University  
of Glasgow

## Fire (Scotland) Act 2005 Fire Risk Assessment Review

Kelvin Building

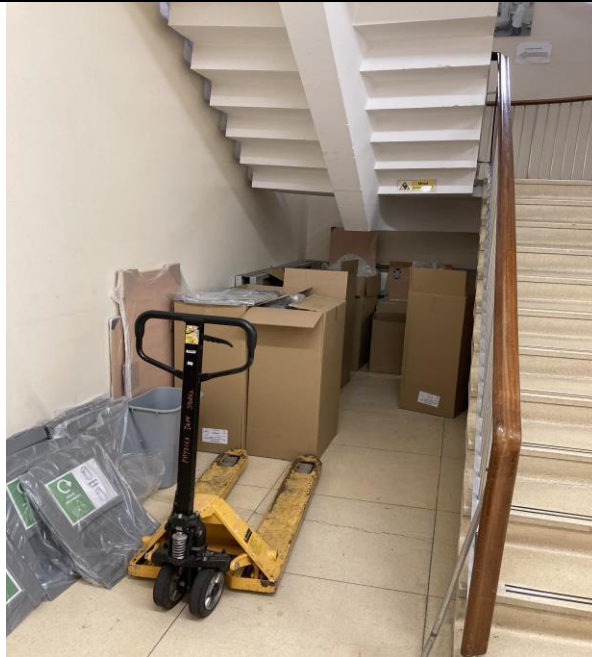
Cylinder compound under external escape stair.

Evidence of fire door requiring maintenance and non-compliant hinges.

Nonstandard fastenings should be removed and replaced as required.

Final exit doors from lecture room require push bars and thumb turn lock removed.

Evidence of no "fire exit keep clear" signage from lecture room.

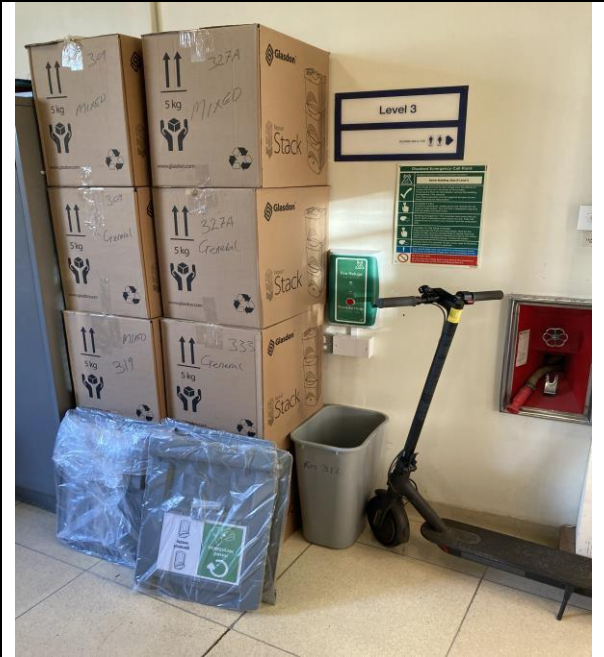
Evidence of wrong mandatory signage on cupboard on escape route.

Bolts on lecture room door.

Evidence of poor housekeeping.

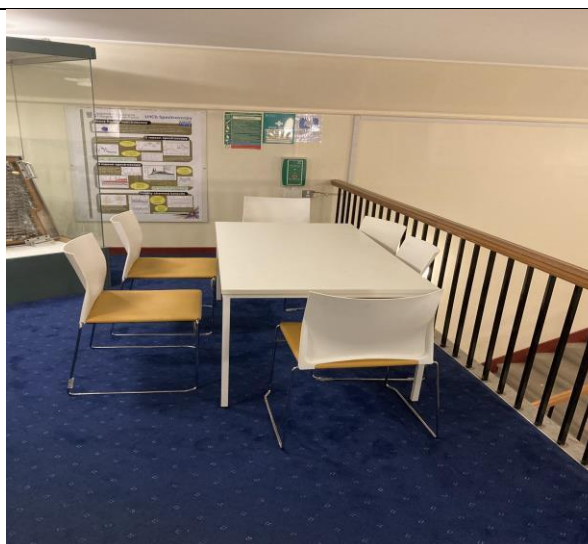
Evidence of poor housekeeping and blocking TWS.

Unsuitable items in an escape route.

Unsuitable items in an escape route and blocking TWS.

Unsuitable items in an escape stair and blocking TWS.

Combustibles stored next to electrical installation.

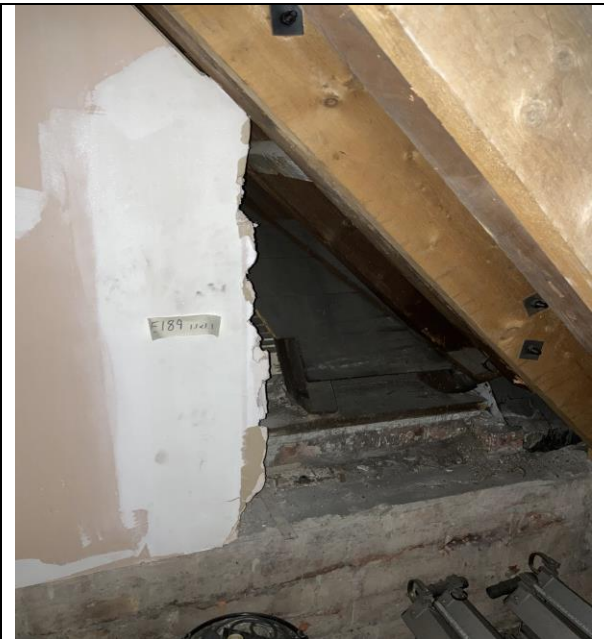
Combustibles stored next to electrical installation.

Combustibles stored next to electrical installation.

Escape routes should not be used as kitchens/tea prep areas.

Escape routes should not be used as a place of work.

Compressed gas cylinder left in cupboard.

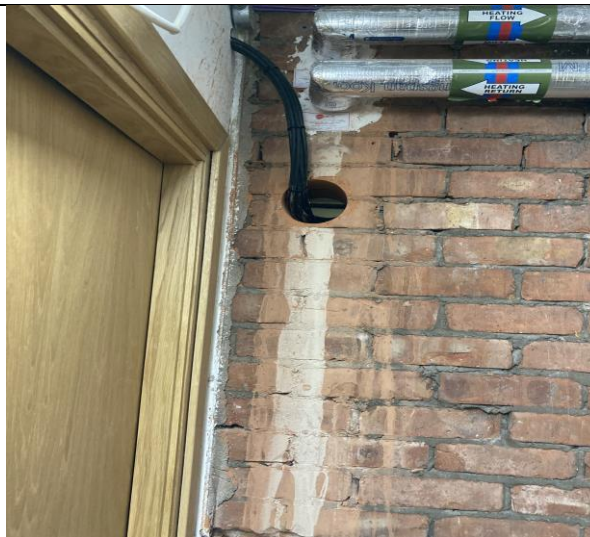
Evidence of daisy chaining.

This room requires to be separated from the escape stair by fire resistant material or removed.

Area (void on L4) for potential fire spread.

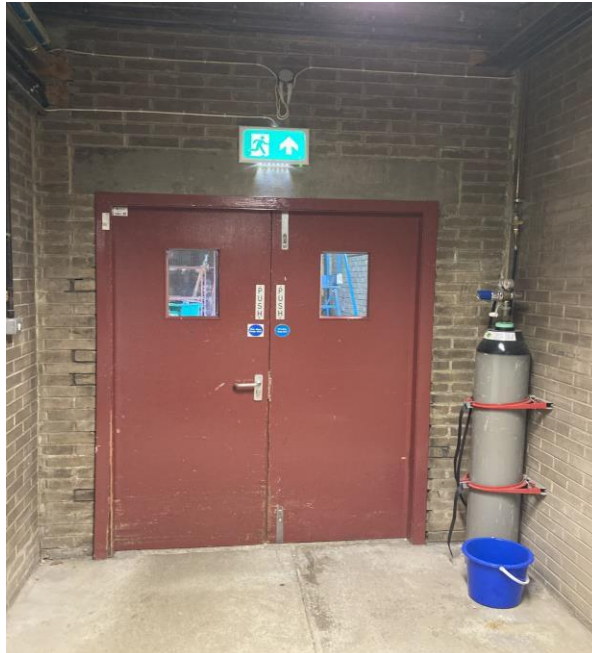
Area (void on L4) for potential fire spread.

Area (L3 stair B) for potential fire spread.

Door has been removed from lobby.
